**Conservation Law Foundation • Earthjustice • Environmental Integrity Project •
Sierra Club**

December 18, 2017

**RE: Response to Statement of Substantial New Questions for Public Comment,
Merrimack Station, NPDES Permit No. NH0001465**

Figure 1: Merrimack Quarterly Heat Input, 1995-Present²¹

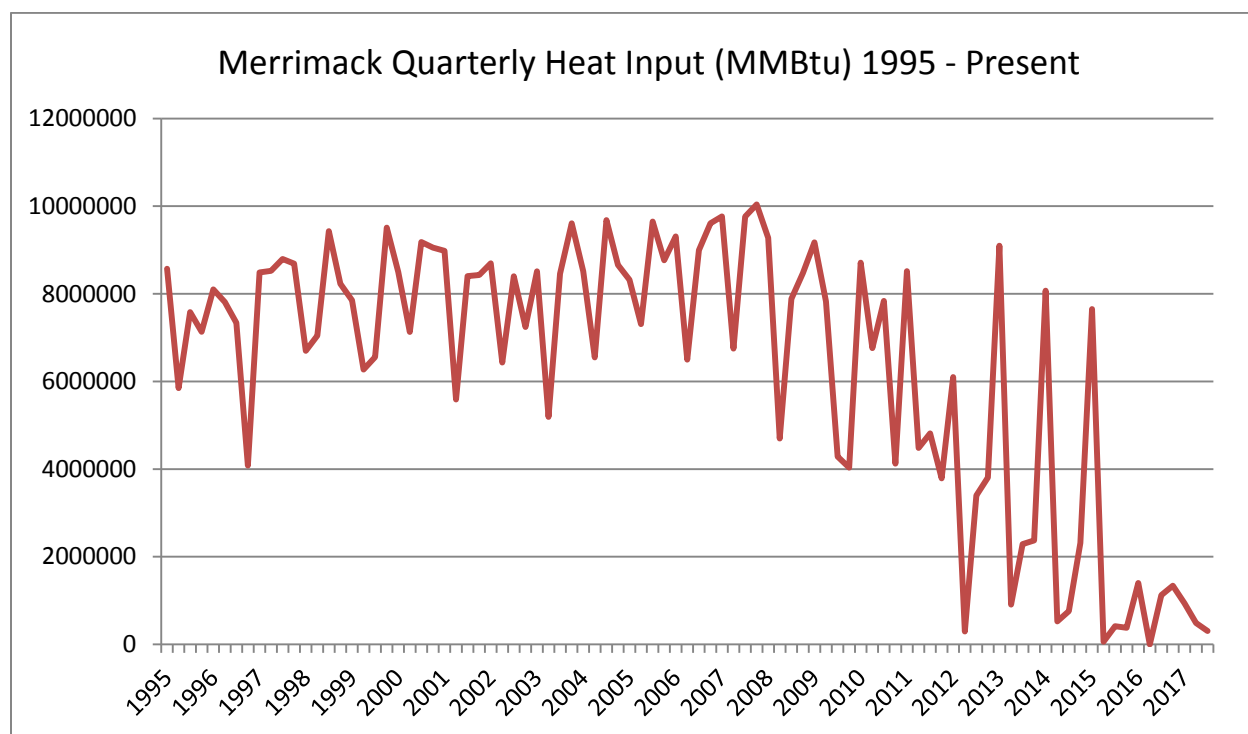
Third, the unfortunate fact is that EPA is extremely slow in issuing NPDES permits for large facilities in New Hampshire, and for Merrimack in particular. These comments are submitted as part of the third round of comments solicited by EPA on this one permit, in a process that started over five years ago. Indeed, Merrimack has been operating under a permit that expired two decades ago, and was issued a *quarter-century* ago. Although Commenters certainly hope that EPA will finalize this permit soon, and will thereafter hew to the five-year permit review cycle mandated by Congress, the history of this permit and this plant raises the possibility that whatever permit EPA does finalize for Merrimack may govern the plant’s operation for many years to come. Just as Merrimack’s operation has changed considerably in the past, it is possible that it will vary considerably in the future.

As such, it would be both irresponsible and contrary to law for EPA to set NPDES permit limits for Merrimack based on an assumption that, because the facility currently operates at a relatively low capacity utilization, certain wastestreams and pollution levels are unlikely to be relatively high in the future and therefore need not be limited.
